STAFF REPORT – 10 May 2013

File No.: SDP13-00001

Project: Lakeside Apartments, Steep Slope Hazard Critical Area Study

Request: To approve the Steep Slope Hazard Critical Area Study in order to re-grade a steep slope

SHEET NUMBER C4 OF 15

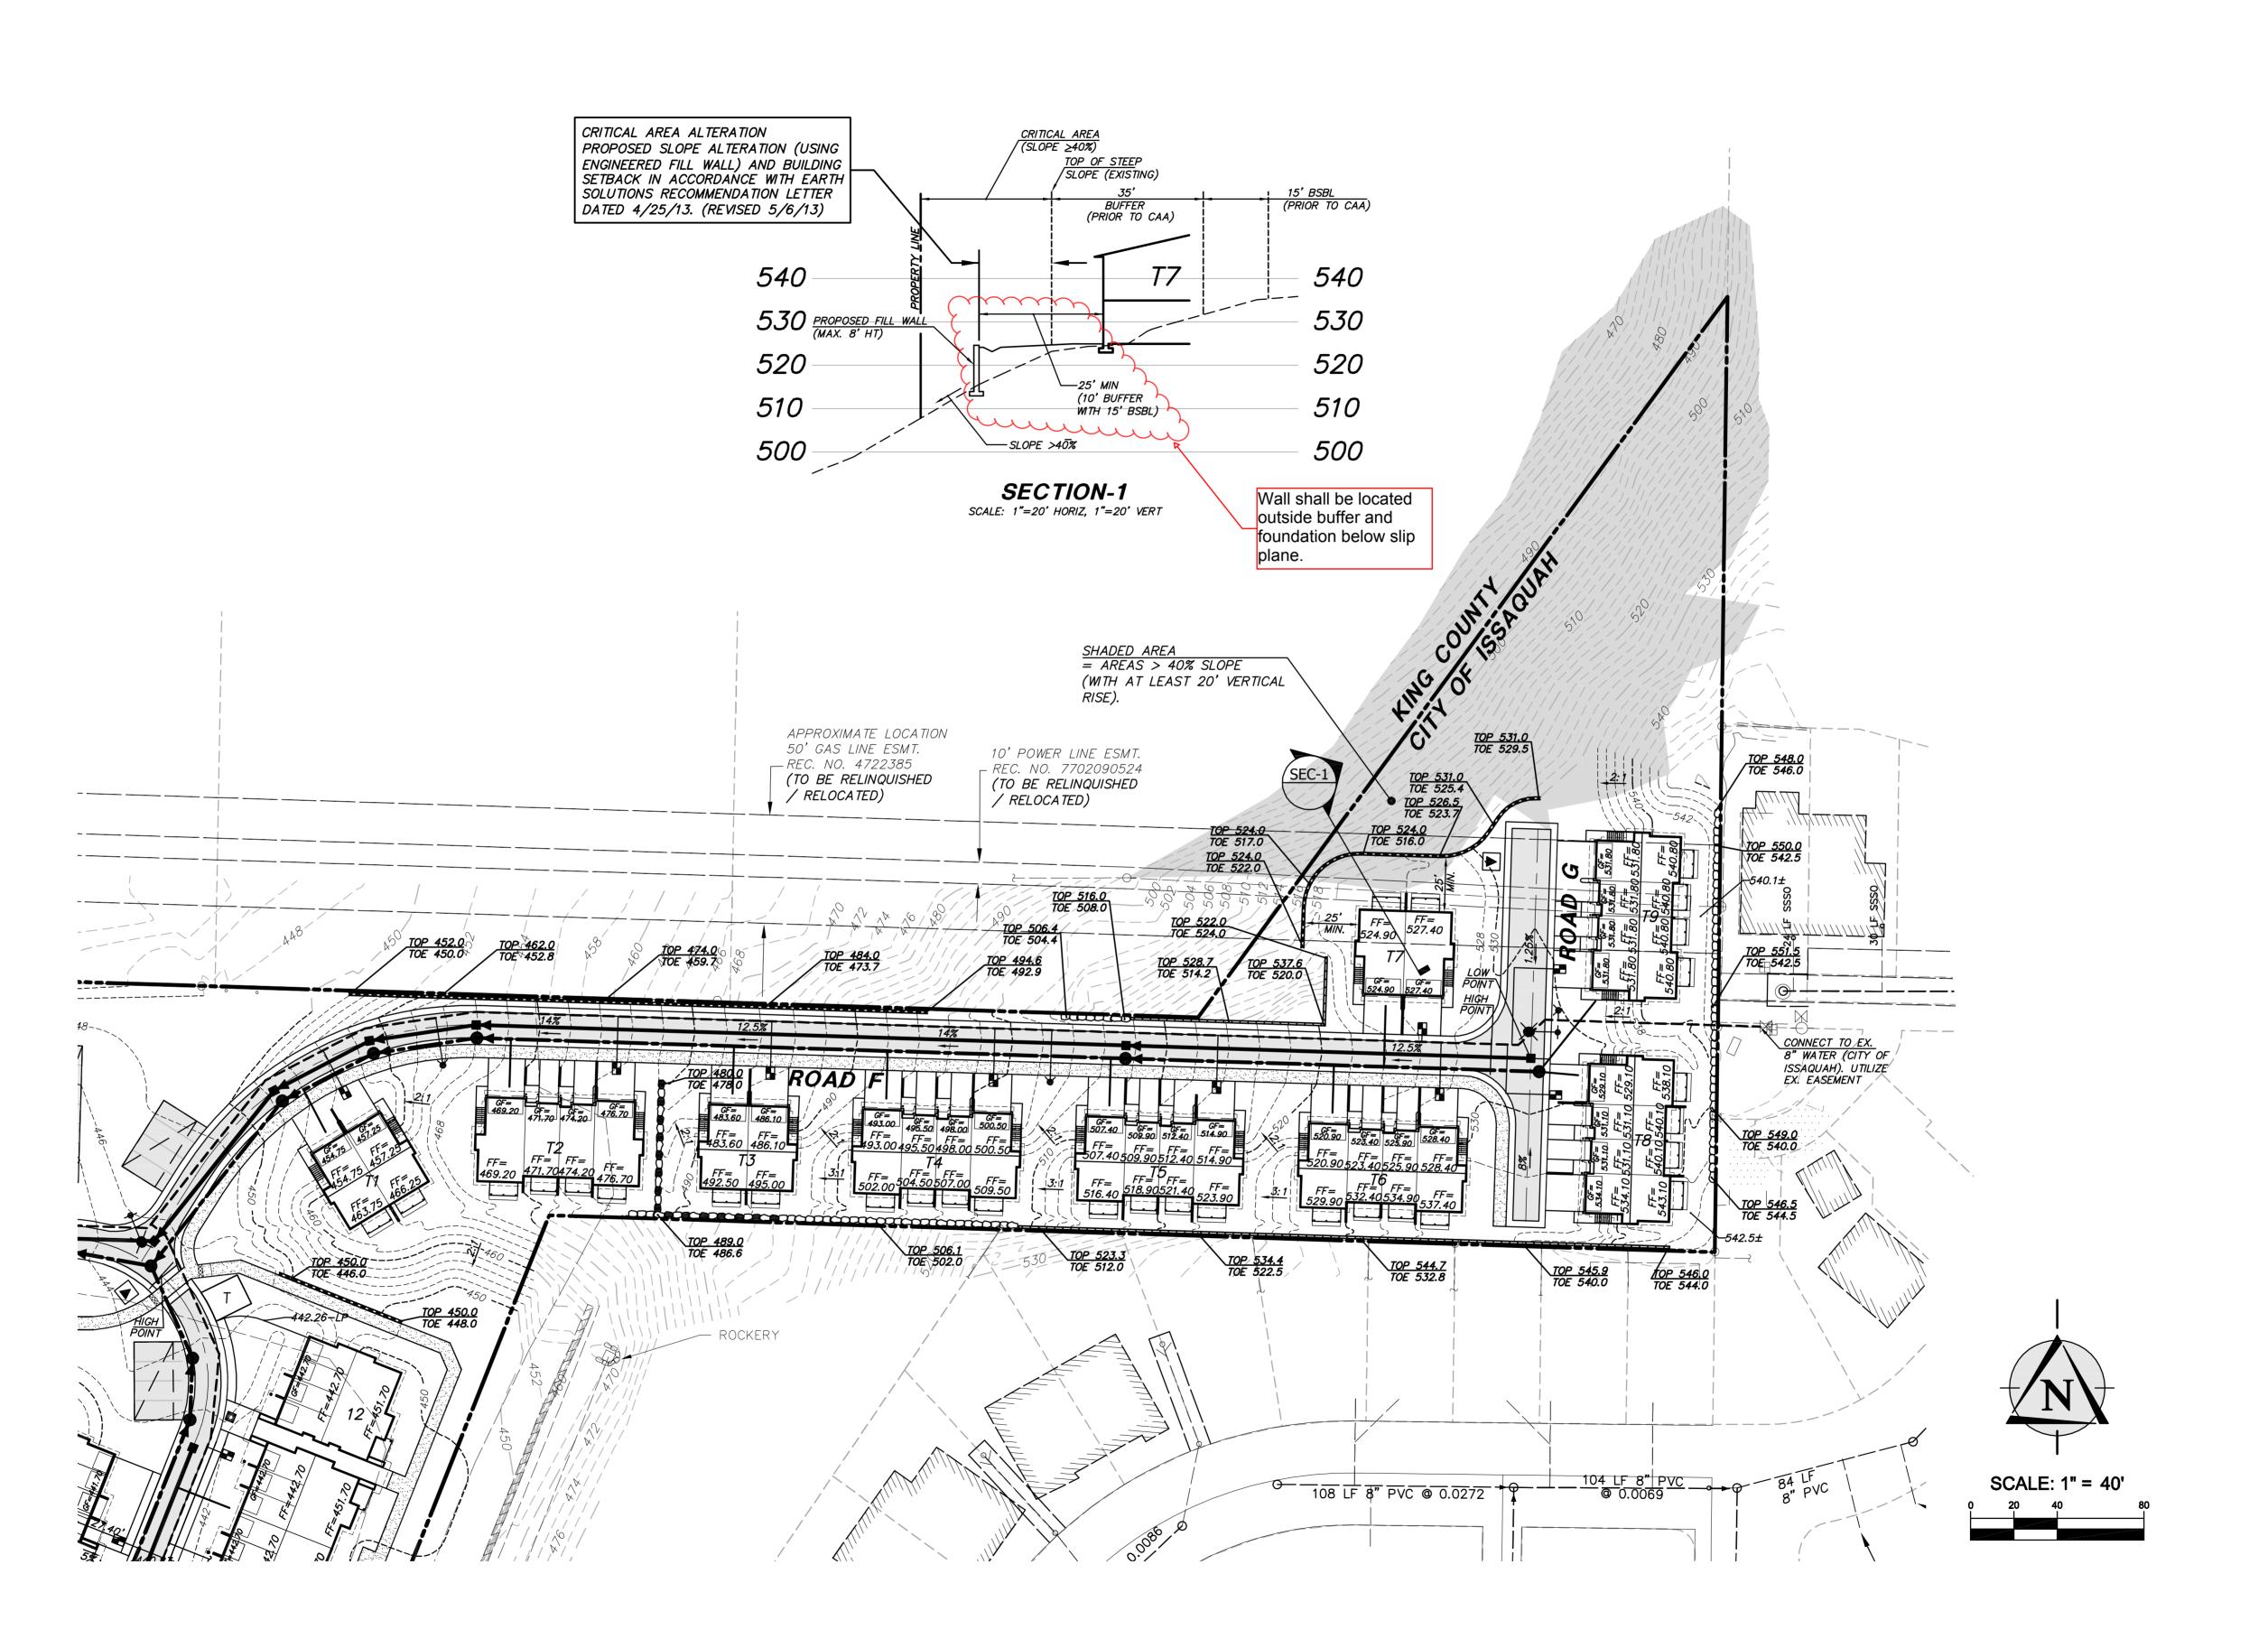
- 2. This Notice of Decision is based on geological information provided by the applicant.
- 3. The proposed grading activity will modify the crest of steep slope within the development; refer to the Preliminary Grading and Utility Plan and Cross Section 1 Detail. The aforementioned identifies the proposed wall alignment.

- 1. The crest of the re-graded steep slope shall be defined as the point at which the slope remains equal to or in excess of forty (40) percent. A 10-foot buffer from the crest of slope and a 15-foot BSBL shall apply.

- 3. The wall shall be constructed outside the 10-foot buffer and the applicant shall provide a geotechnical certification that the construction of the wall met the recommendations of the geotechnical report submitted for this Critical Area Study and the conditions herein.

- 4. The foundation of the wall shall be such that it is located below the slip plane of the steep slope as defined in the subject Critical Area Study.
